## **PETITION EXHIBIT 11**

Re: 425 Tennant Ave, Morgan Hill, Santa Clara County; Cleanup Or  
Abatement Order No. R3-2006-0112, Which Amends Cleanup Or  
Abatement Order No. R3-2005-0014

Subject: Olin Response to Central Coast Water Board Comments  
SLIC: 425 Tennant Ave, Morgan Hill  
Second and Third Quarter 2006 Groundwater Monitoring Reports,  
and East of Site Characterization Report  
MACTEC Project No. 6100070002-09.07

**RE: REVIEW OF OLIN CORPORATION REPORTS: (1) LLAGAS SUBBASIN  
CLEANUP WORKPLAN, JUNE 15, 2007; (2) SECOND QUARTER 2007  
GROUNDWATER MONITORING REPORT, JULY 30, 2007**

**Spatial Distribution of Concentration Trends**  
 Deep Aquifer  
 Second Quarter 2007 Groundwater Monitoring Report  
 Olin/Standard Fusee Site  
 Morgan Hill, California

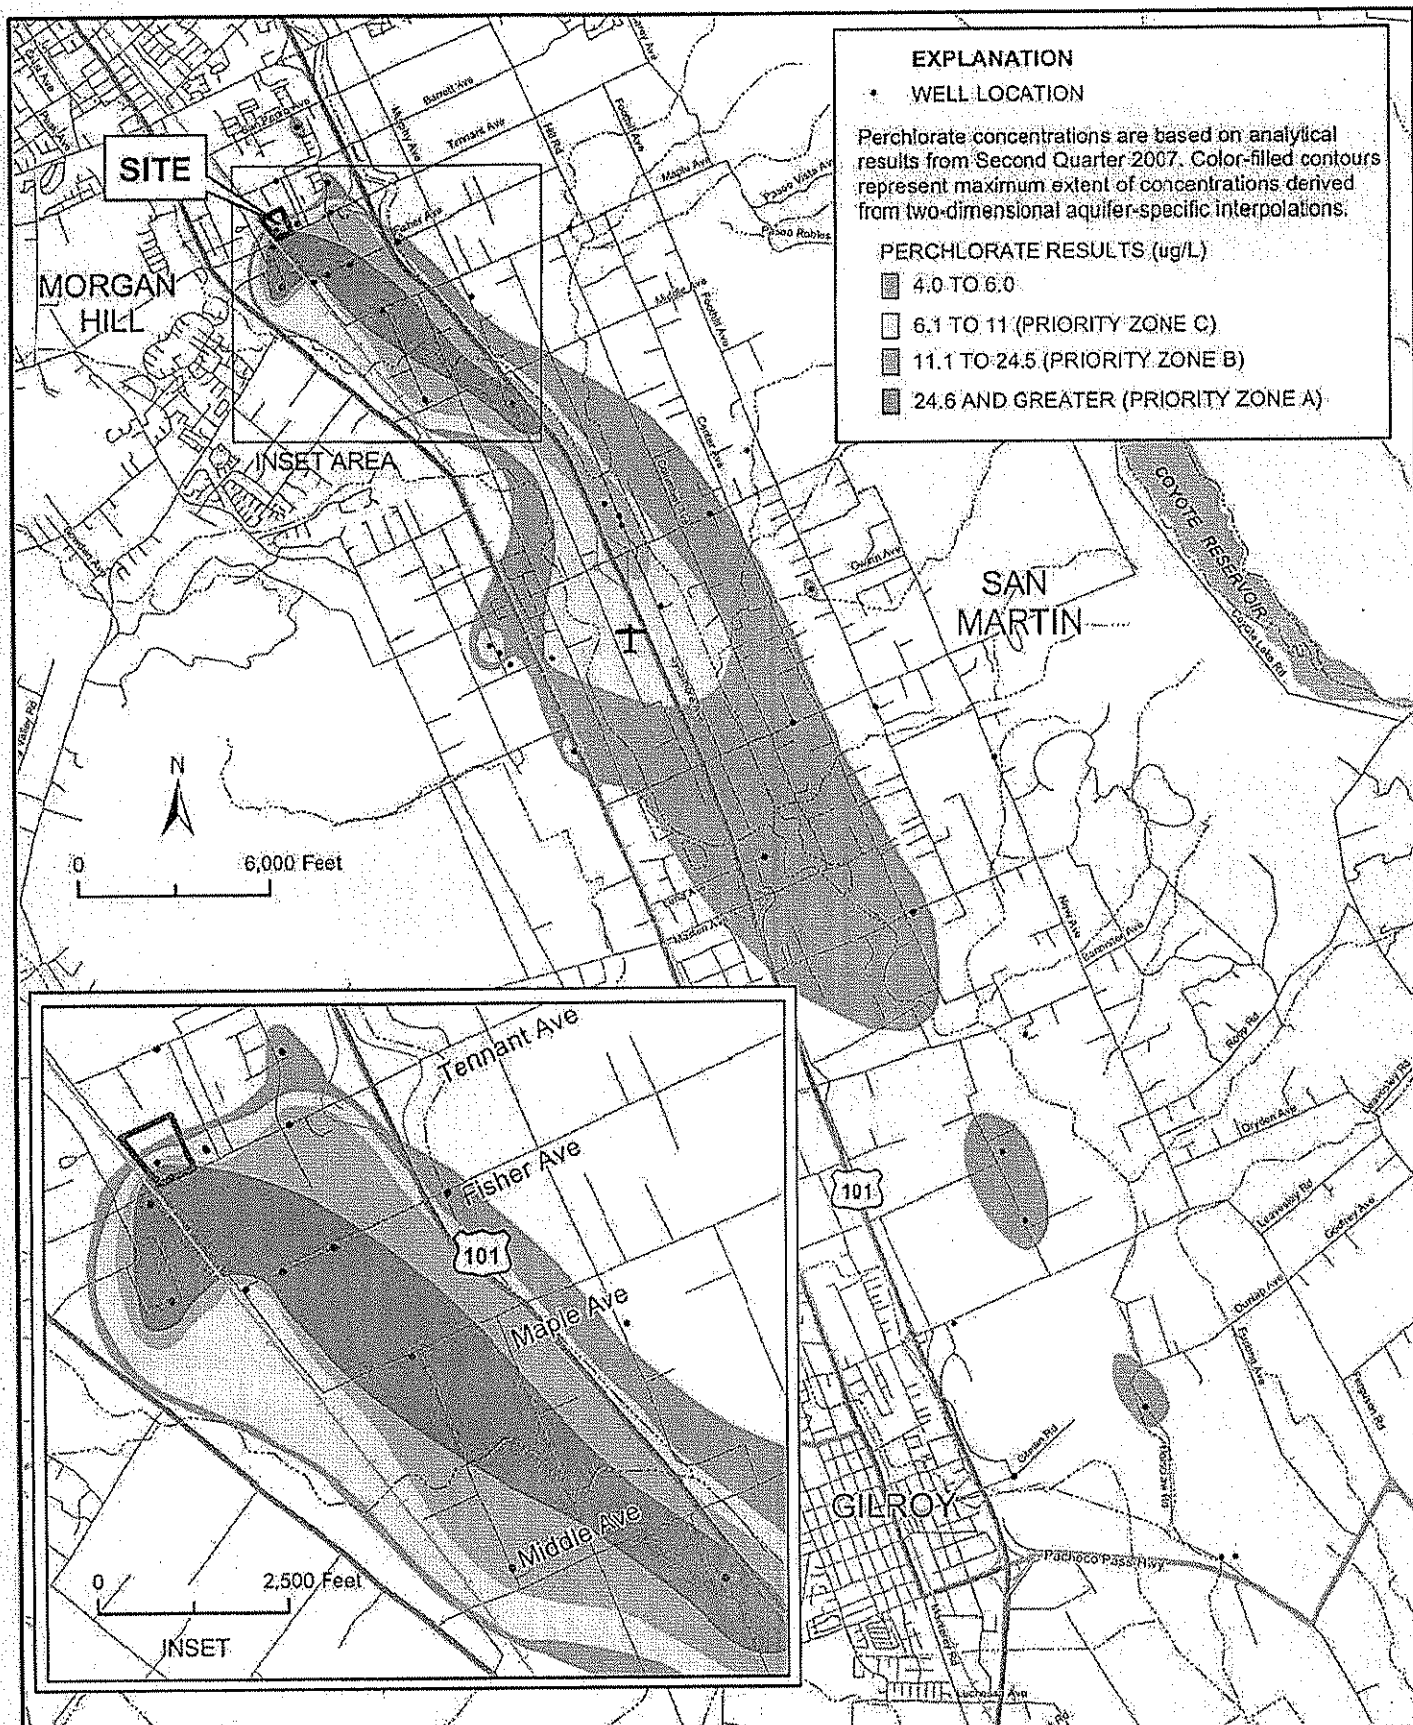
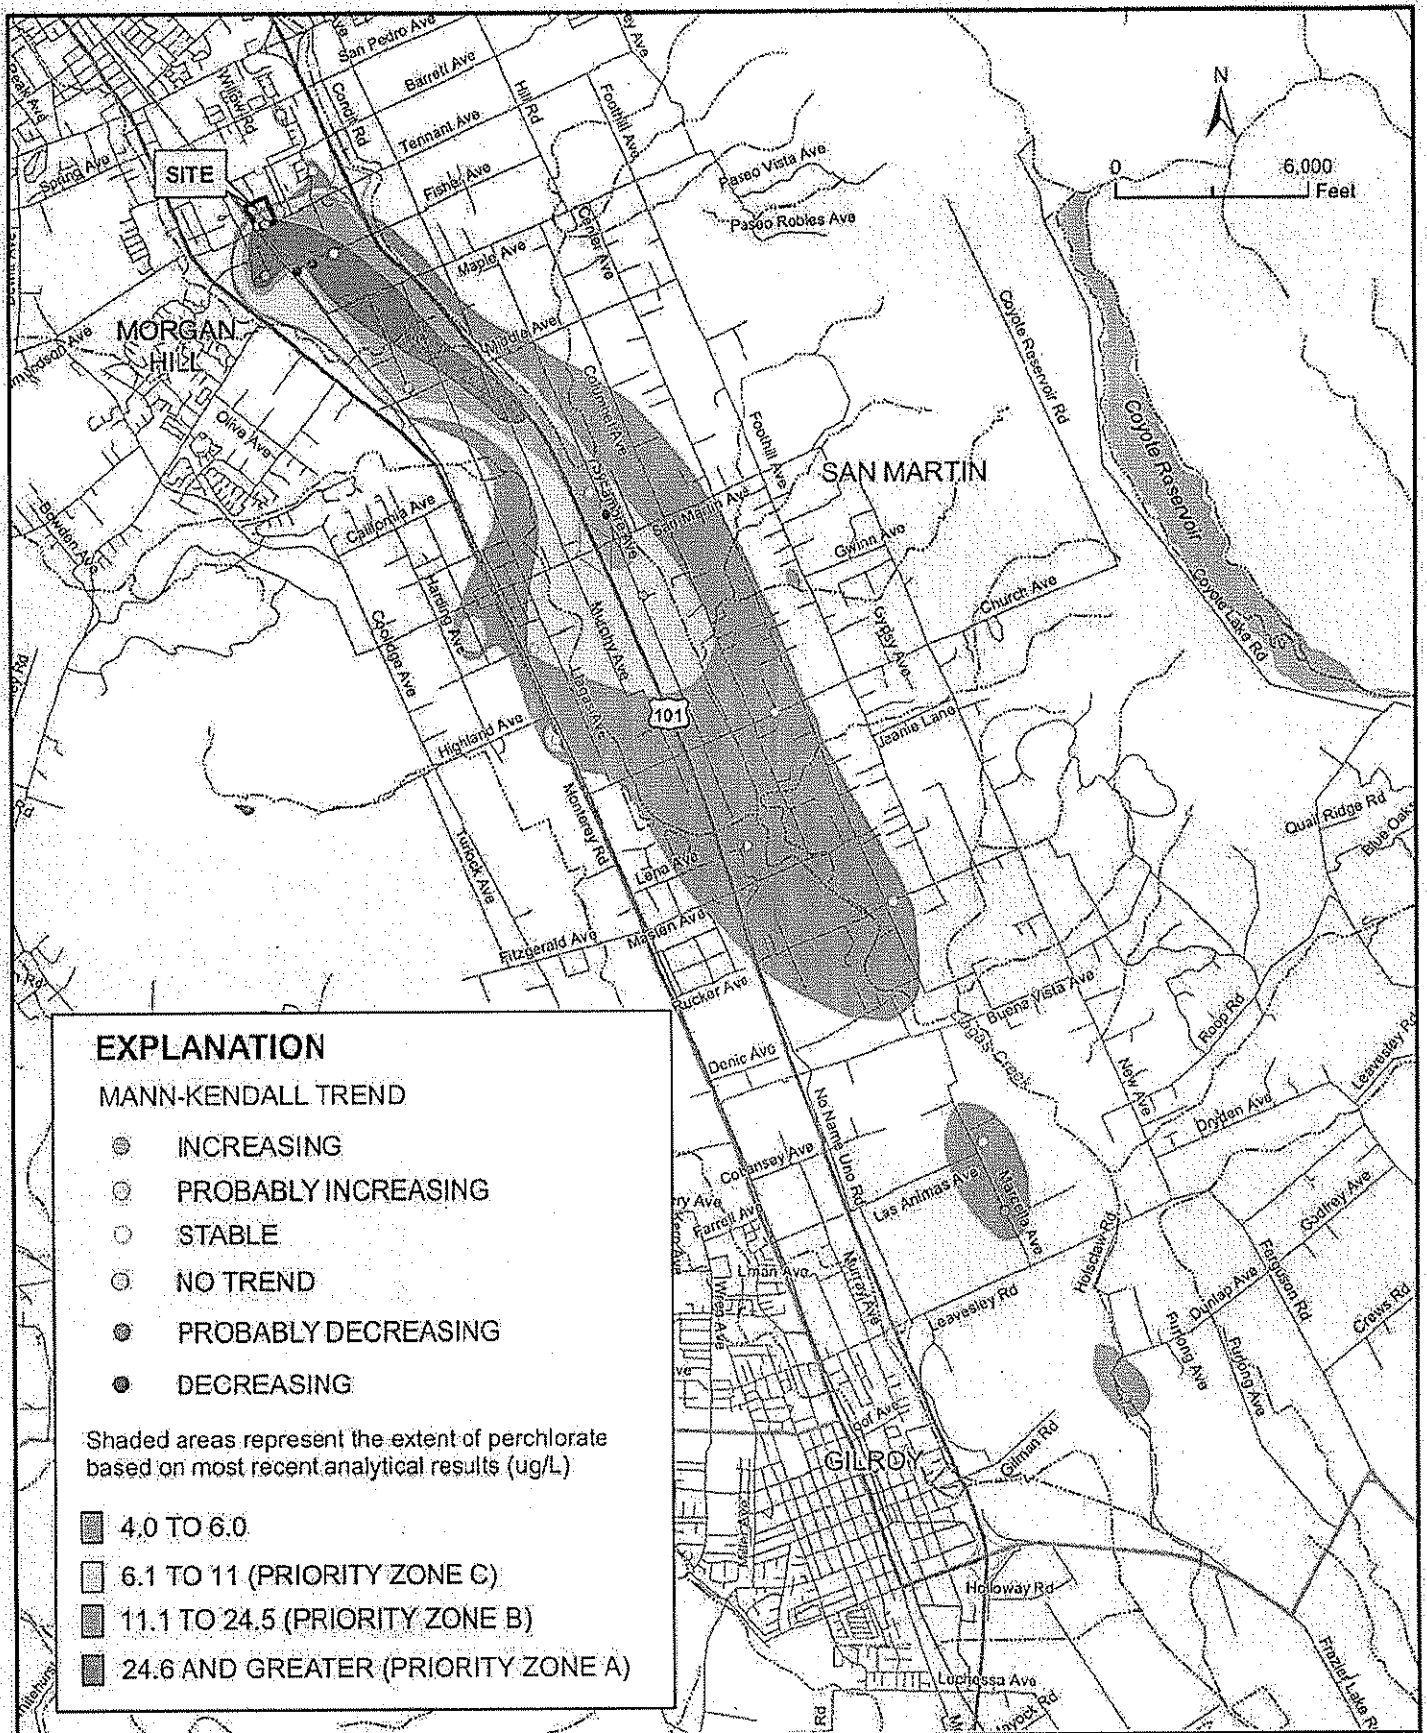
- c) The trend analysis for perchlorate in the Deep Aquifer does not appear to have been thoroughly analyzed by Olin, at least in terms of their mapping of perchlorate trends in the Deep Aquifer shown in Figure 3.27. In the Q2 Report, Olin makes reference to the Mann-Kendall analysis of trend only for domestic wells. There is no reference to the Mann-Kendall analysis for their own monitoring wells. This oversight is not acceptable since reliable data for the Deep Aquifer zone are almost entirely from Olin's monitoring wells, not domestic wells. The mapping of perchlorate trend in the Deep Aquifer (Figure 3.27) does appear to show data points corresponding to selected monitoring wells, however if this is the case, the related trend analysis is completely undocumented in the Q2 Report.

The following 21 monitoring wells meet Olin's criteria for Mann-Kendall analysis (greater than four samples with at least half the results above the reporting limit of 4 ug/L) and yet do not appear to have been plotted by Olin on Figure 3.27 or otherwise discussed by Olin in the Q2 Report (note: in parentheses, number of detections > 4 ug/L / number of samples):
